RESEARCH REACTOR CENTER

August 24, 2011

SUBJECT: Written communication as specified by 10 CFR 50.4 regarding an application to amend Amended Facility License R-103 by revising the University of Missouri-Columbia Research Reactor Technical Specification 2.1, "Reactor Core Safety Limit," pursuant to 10 CFR 50.90

Figure F.2 – MURR Safety Limit Curves for Pressurizer Pressure at 75 PSIA

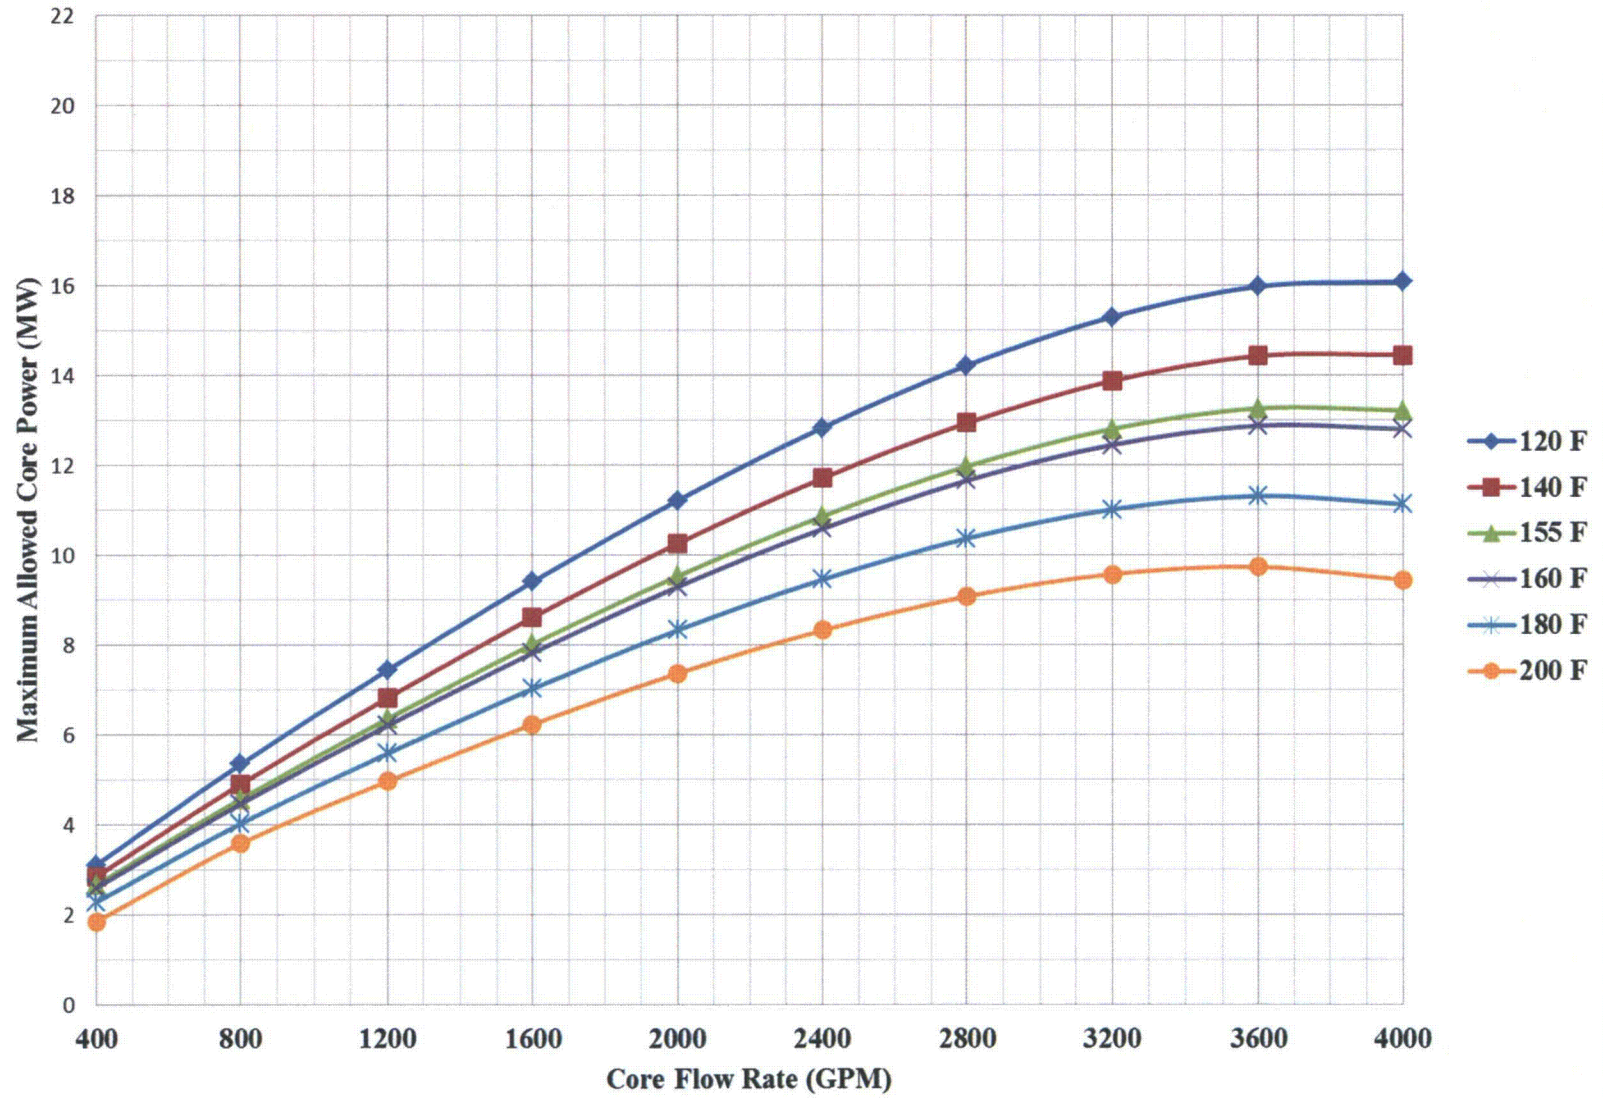
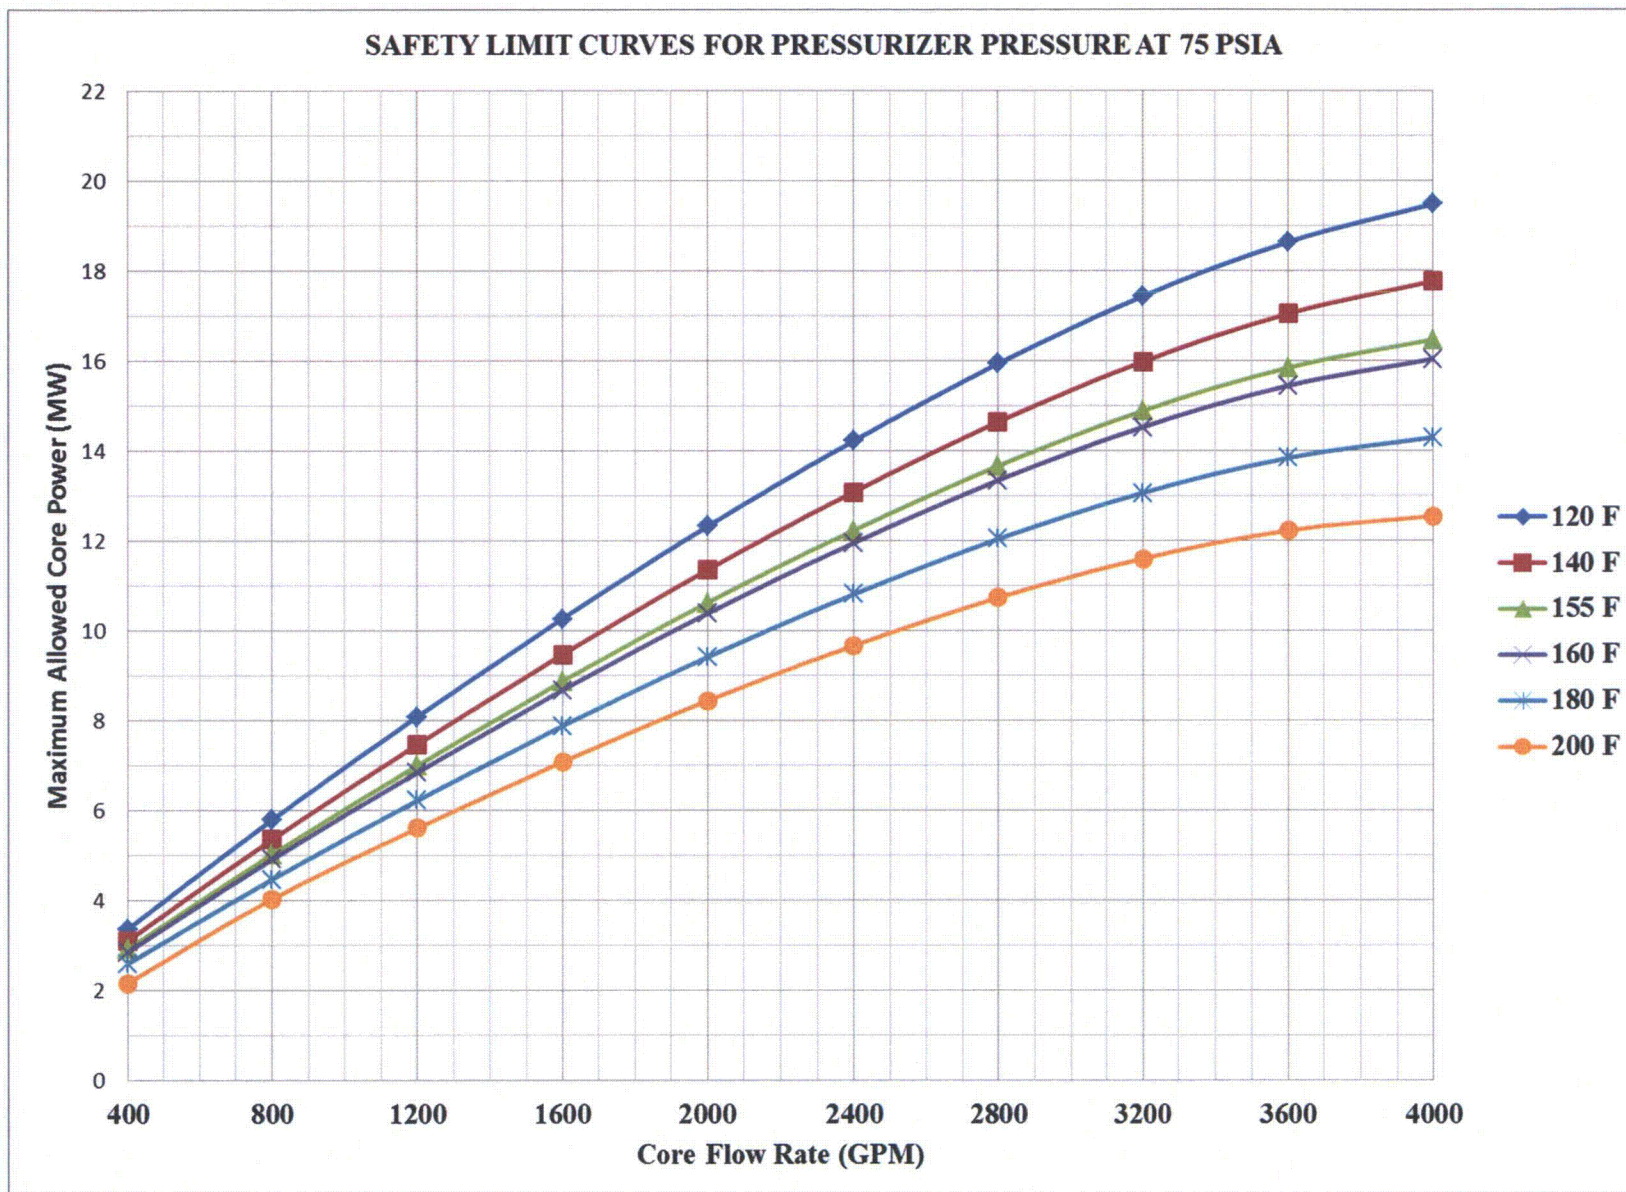
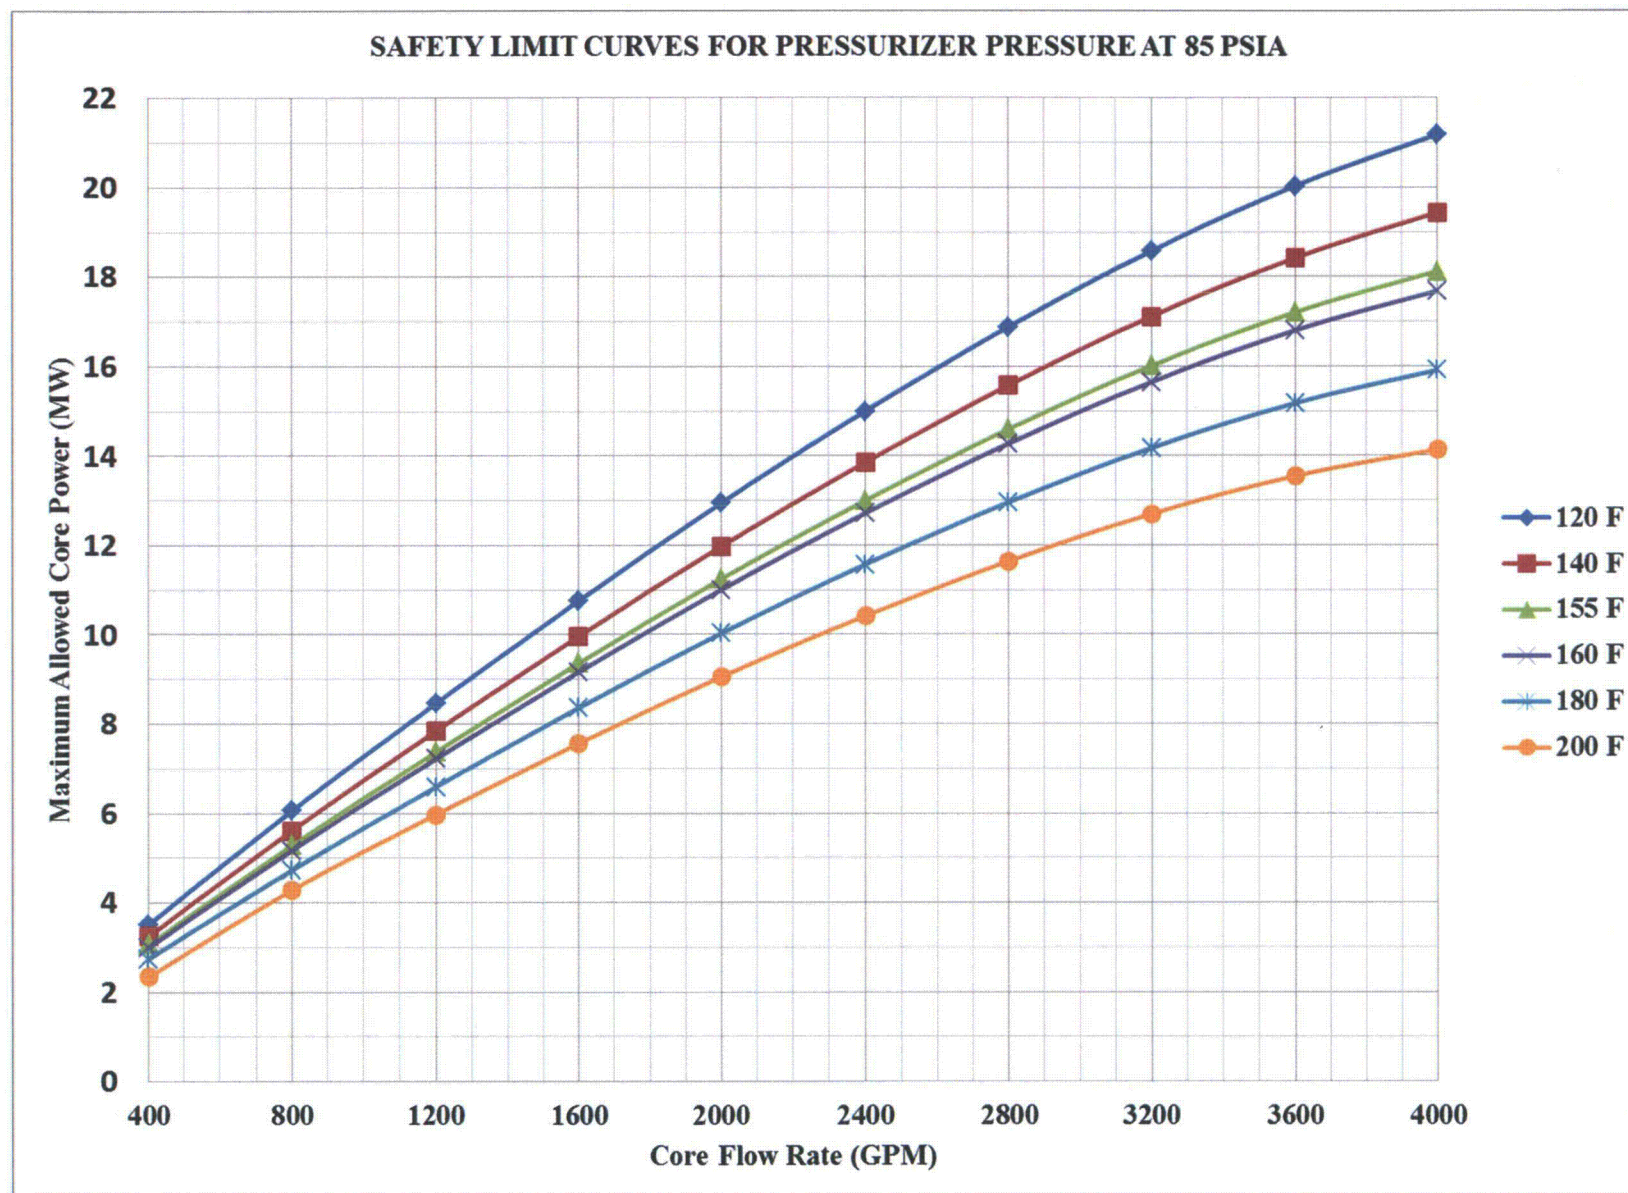
Revised SL tables and curves for Mode I and II operation have been developed applying the correct Bernath D_i definition, however no changes to the current MURR LSSSs are required in order to maintain approximately the same safety margins. Additionally, the safety analysis for Mode III operation is based on the original 5.2 Kg ^{235}U alloy fuel which assumed a combination of power peaking factors that exceed the combined power peaking factors for the current 6.2 Kg ^{235}U aluminide fuel core. Therefore, the analysis in Section 5.5.3 still conservatively envelopes Mode III operation of the MURR and requires no revision.

With the revised curves, the MURR has a new SL of 14.894 MW for Mode I operation with all three (3) non-power LSSS variables set at their corresponding limits, i.e. primary coolant pressurizer pressure at 75 psia, total core flow rate at 3200 gpm, and reactor inlet water temperature at 155 °F. This provides a 2.39 MW margin between the reactor power LSSS of 12.5 MW and the SL. This is actually slightly higher than the previous NUS Corporation calculated SL of 14.892 MW. For Mode II operation, with the revised SL curves, the MURR has a new SL of 8.763 MW with all three (3) non-power LSSS variables once again set at their corresponding limits, i.e. primary coolant pressurizer pressure at 75 psia, total core

flow rate at 1575 gpm, and reactor inlet water temperature at 155 °F. This provides a 2.51 MW margin between the reactor power LSSS of 6.25 MW and the SL.

Figure H.1 – MURR CHF Curve Mode I Operation for Pressurizer Pressure at 75 PSIA

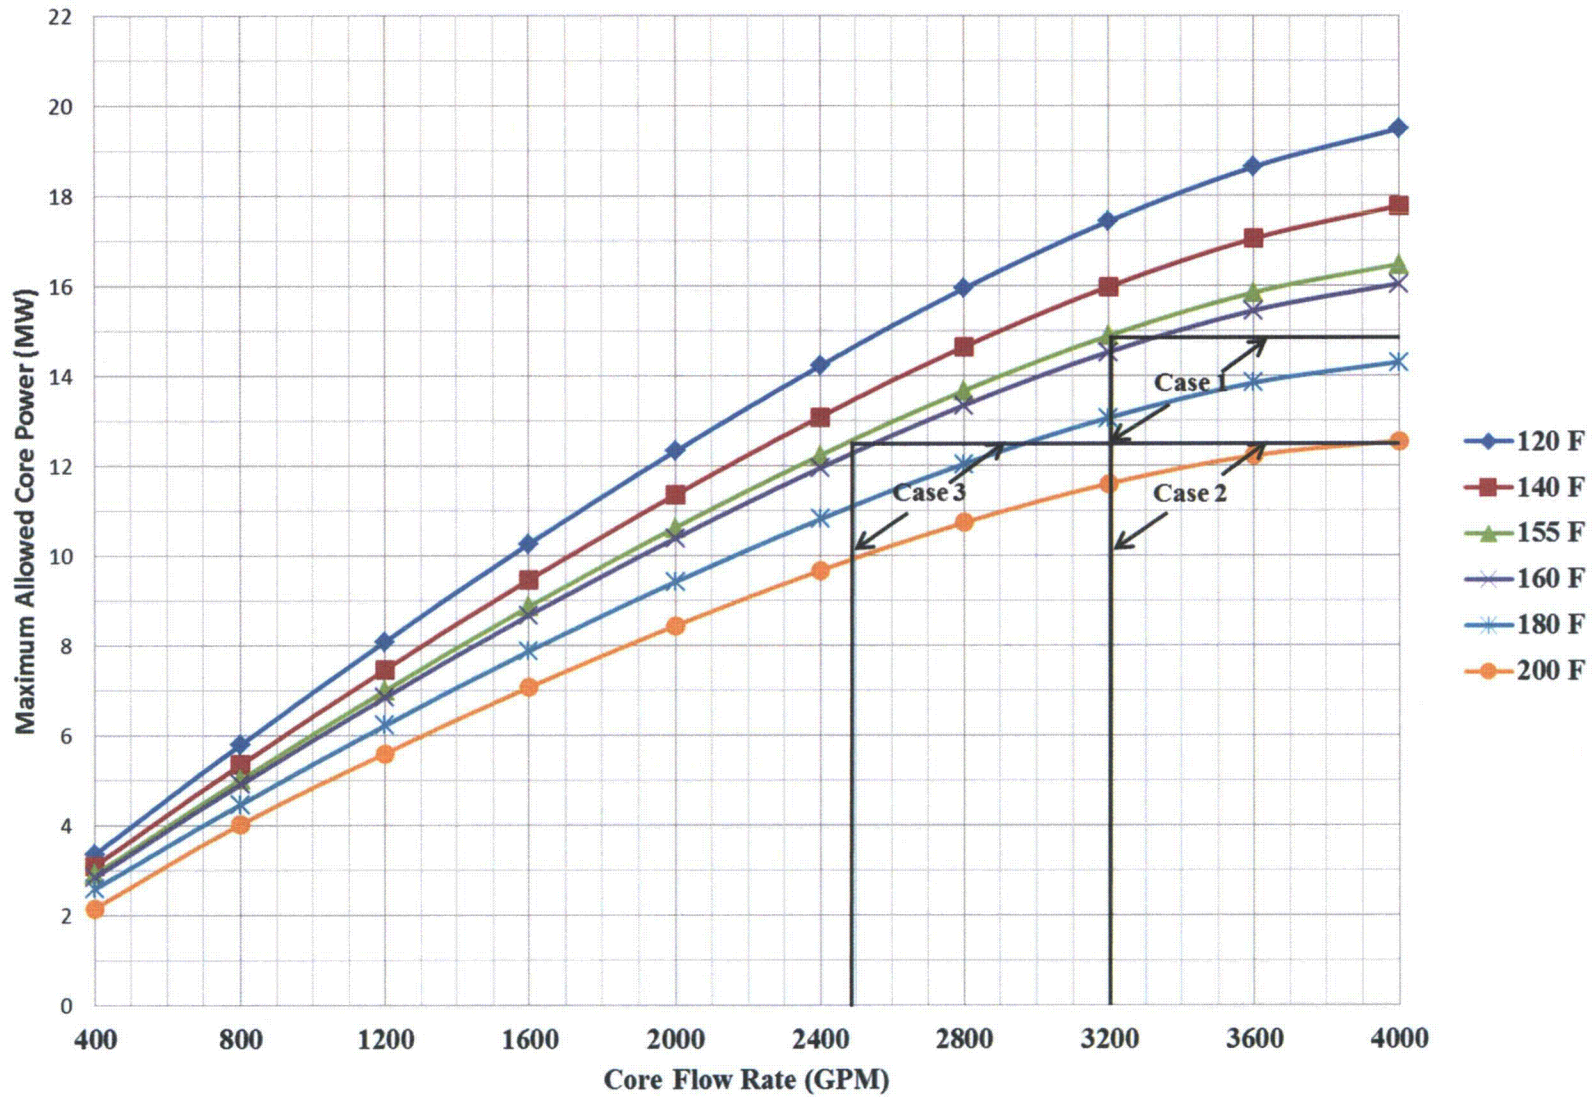
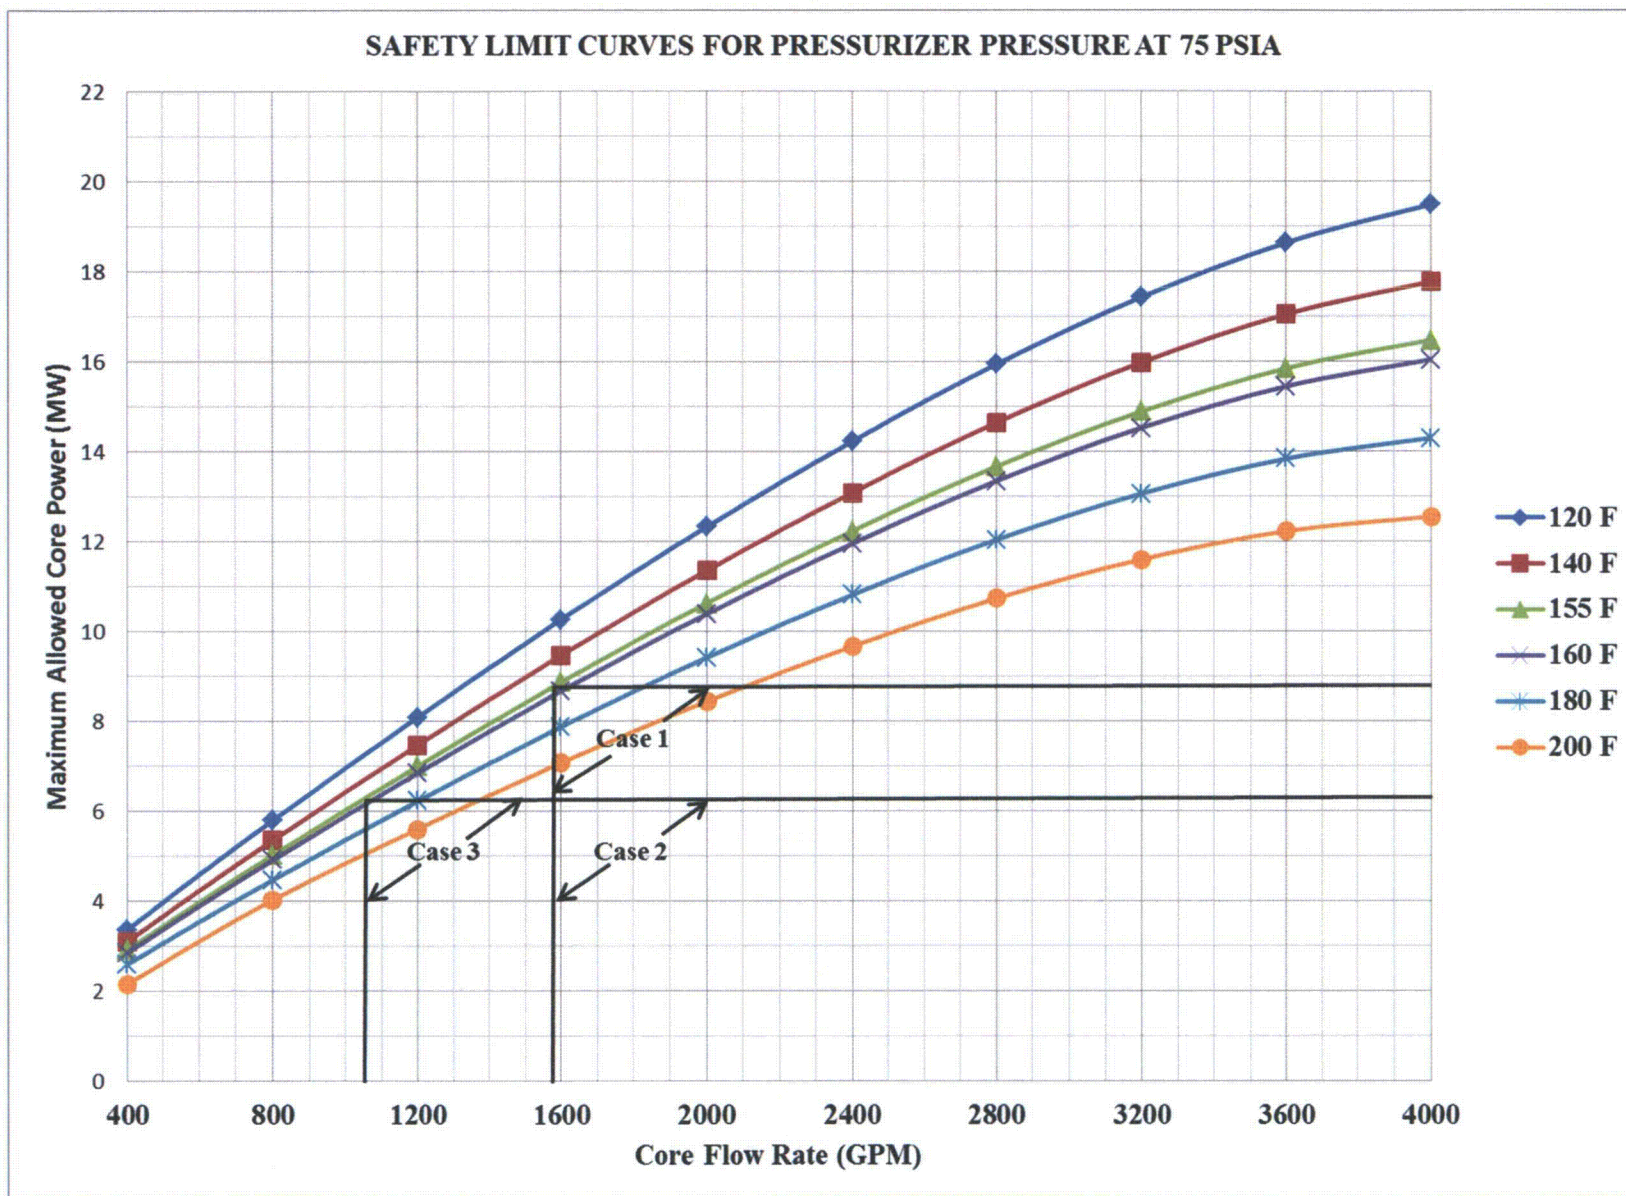
1 predicts CHF at 8.766 MW, i.e. 2.516 MW above the LSSS of 6.25 MW for Mode II. Case 2 results indicate that the reactor could be operated with a reactor inlet water temperature of 219 °F for Mode II before reaching CHF. Case 3 shows CHF occurring only with total core flow reduced to 1045 gpm or 530 gpm less than a core flow rate of 1575 gpm. Thus the safety margin is 34% of the 1575 gpm core flow rate corresponding to the LSSS flow value for Mode II operation as compared to 23% for Mode I operation.
